**SUBMITTAL TO THE BOARD OF SUPERVISORS  
COUNTY OF RIVERSIDE, STATE OF CALIFORNIA**

**SUBJECT:** Contract Change Order No. 10 - between the County of Riverside and Griffith Company for the replacement of Van Buren Boulevard Bridge over Santa Ana River, Riverside Area

Contract Change Order No. 10 became necessary in order to construct the modification of drainage system no. 5 in accordance with the new/red-lined/revised sheets 59R1, 59A, 59B and 60R2 of 136 of the Van Buren Bridge plans. The storm drain system is modified to accommodate the anticipated increased storm drainage from the proposed Clay St. railroad grade separation project.

Contract Change Order No. 10

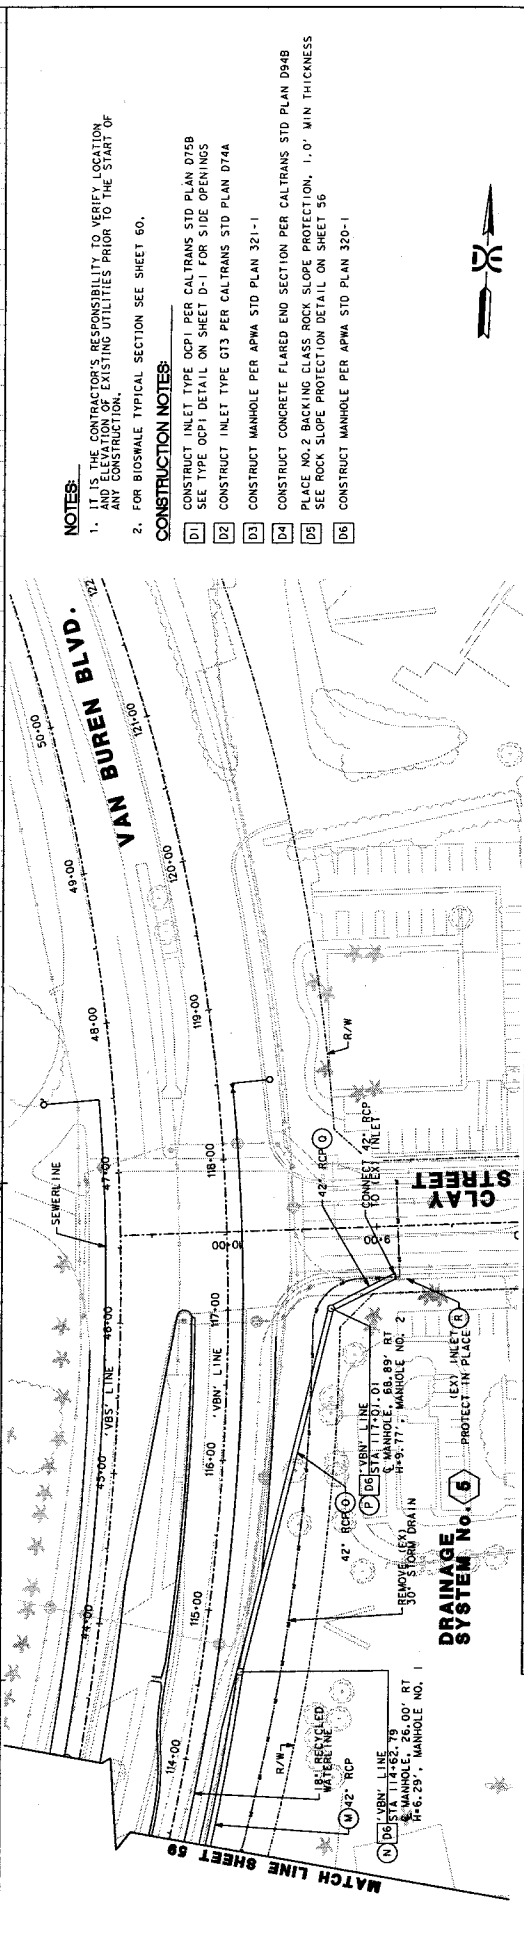
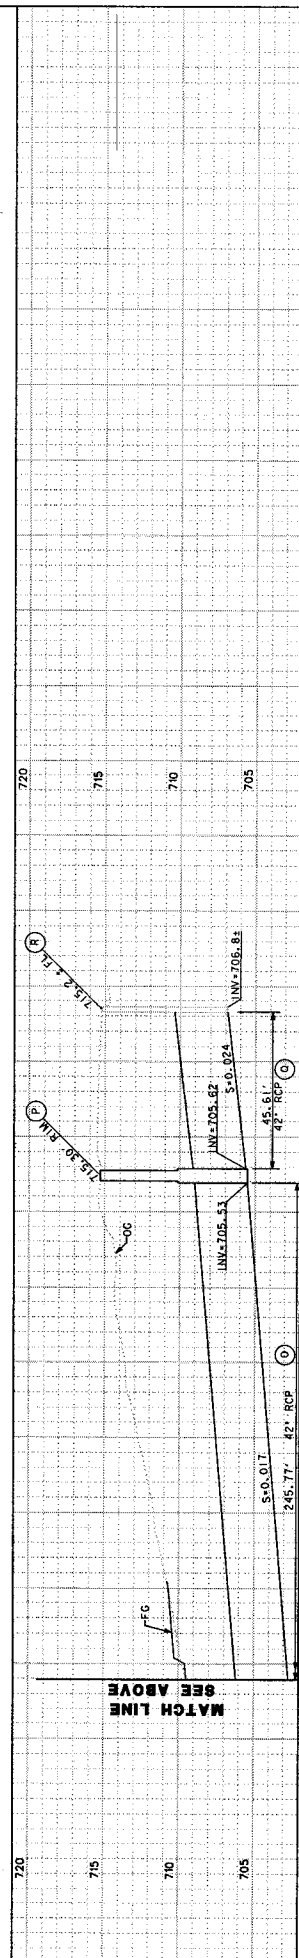
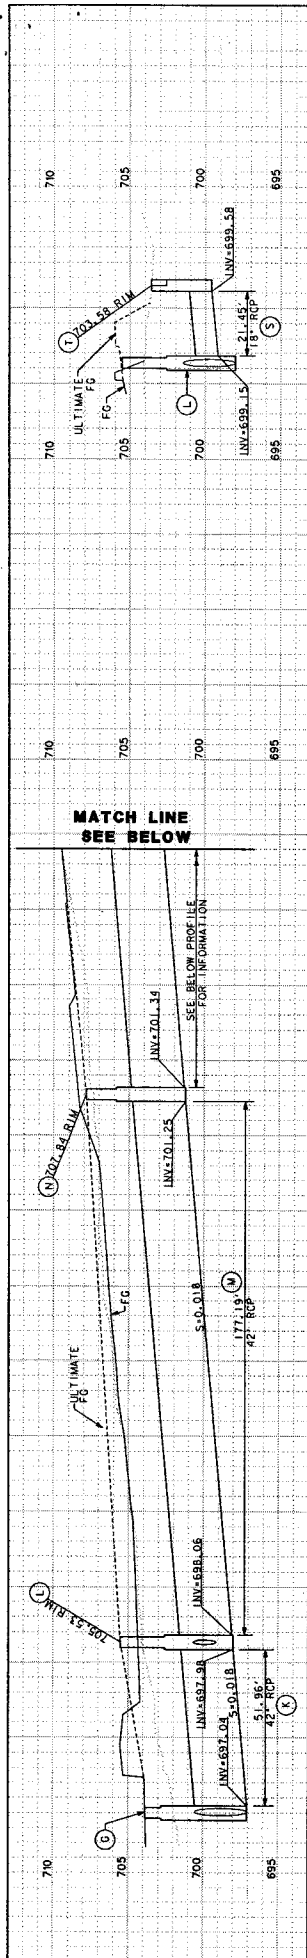
As directed by the Engineer and in accordance with the applicable sections of the Special Provisions; compensate the Contractor to construct the modification of storm drain system no. 5 in accordance with the new/red-lined/ revised plans sheets 59R1, 59A, 59B and 60R2 of 136 and numbered as sheets 3 thru 6 of this contract change order. The modification is in anticipation of the Clay St. railroad grade separation project which will result in increased drainage discharge to the existing storm drain system. The unit prices include; but not limited to, furnishing labor, equipment and materials in completing the work in place as follows:

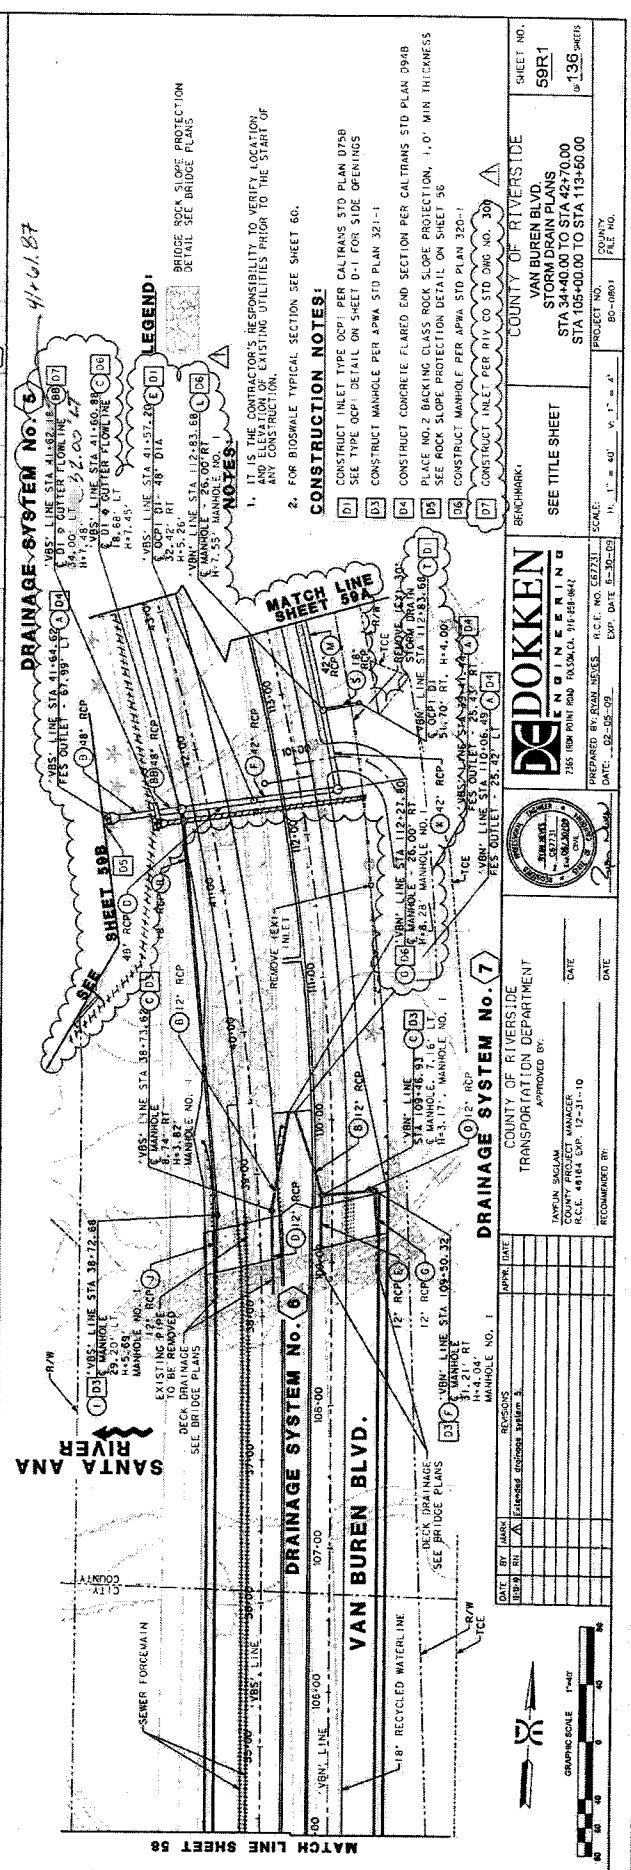
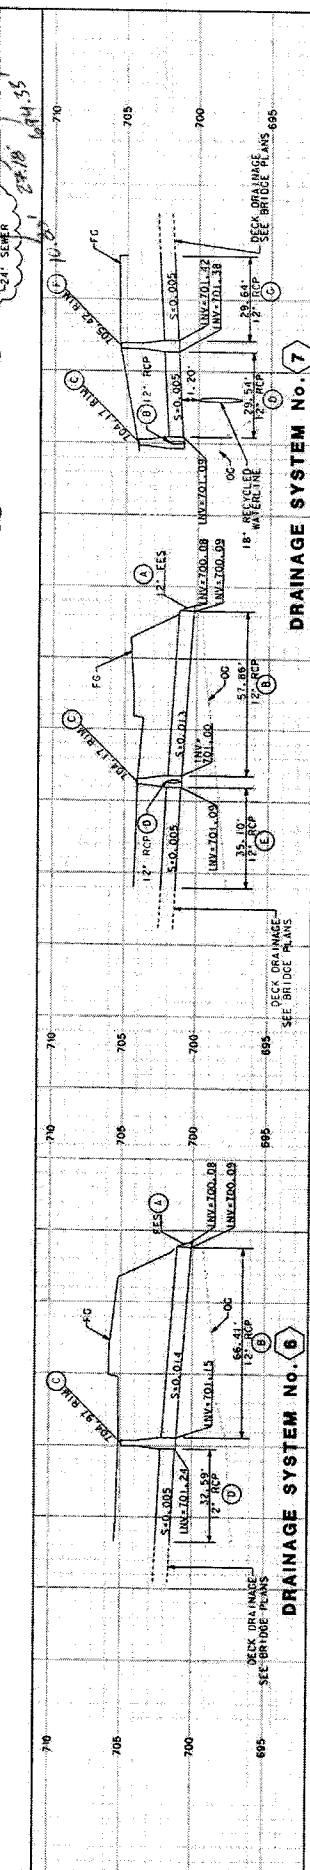
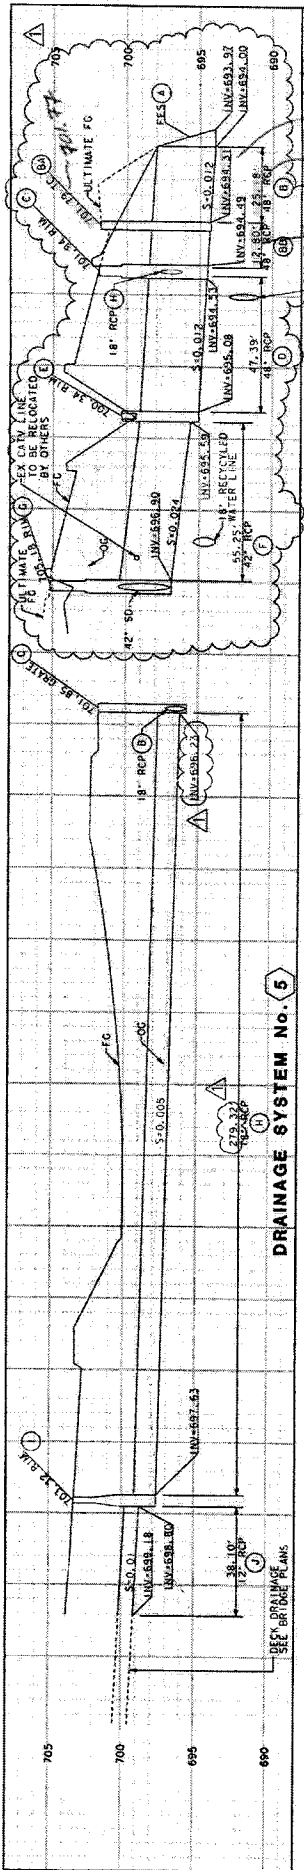
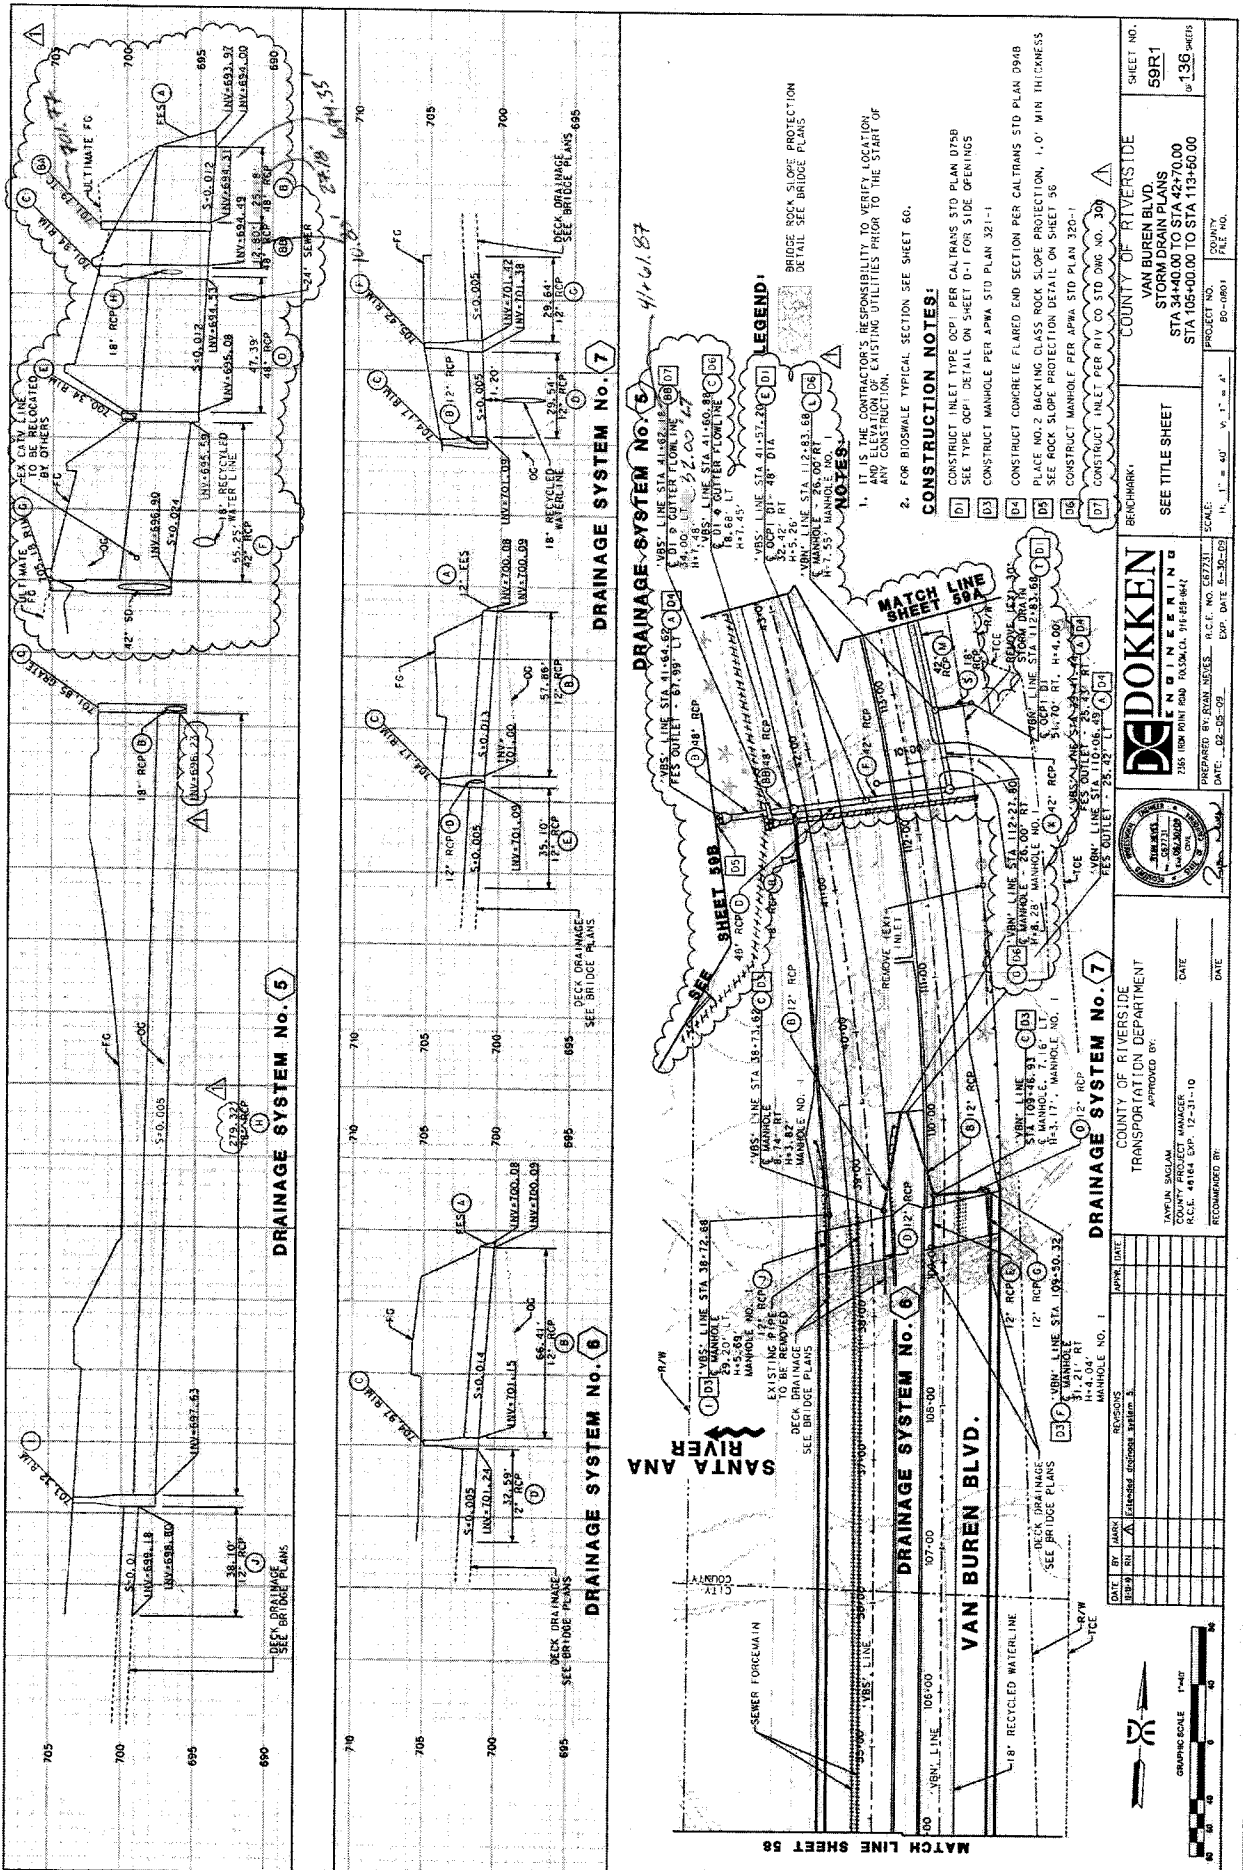
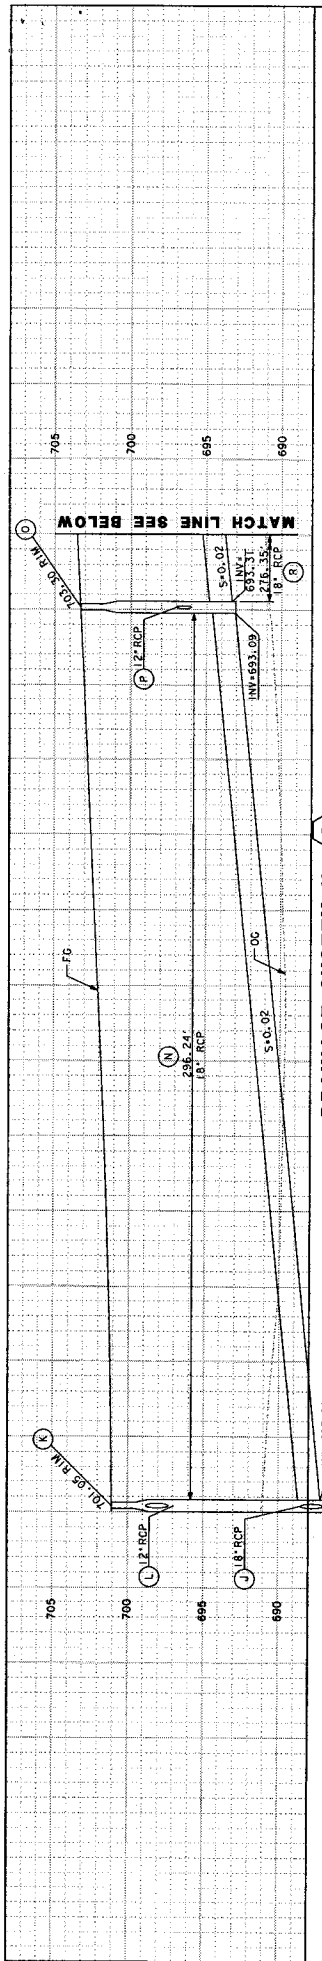
DATE	BY	REVISIONS	DATE
08/29/00	JKM	1. A. Revised stationing

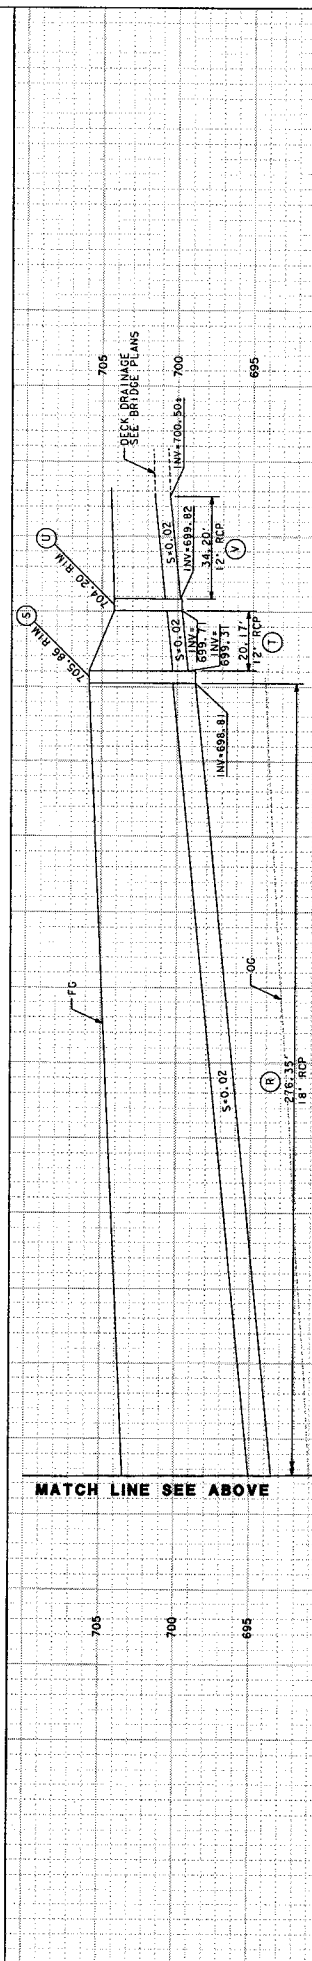
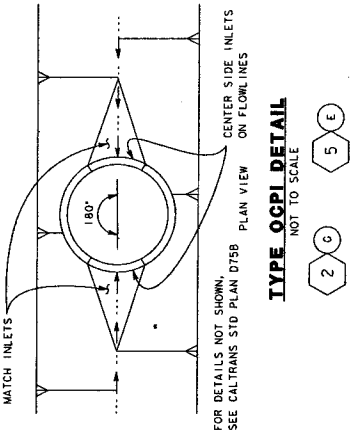
DATE		BY	MARK	REVISIONS	APPR.	DATE
12-15-11		SR	SR	1. Revised profile for drainage system number 2		
12-15-11		SR	SR	2. Revised bioswale typical section		
<p>COUNTY OF RIVERSIDE                  VAN BUREN BLVD.                  STORM DRAIN PLANS                  STA 344+00.00 TO STA 42+70.00                  STA 105+00.00 TO STA 113+50.00</p>
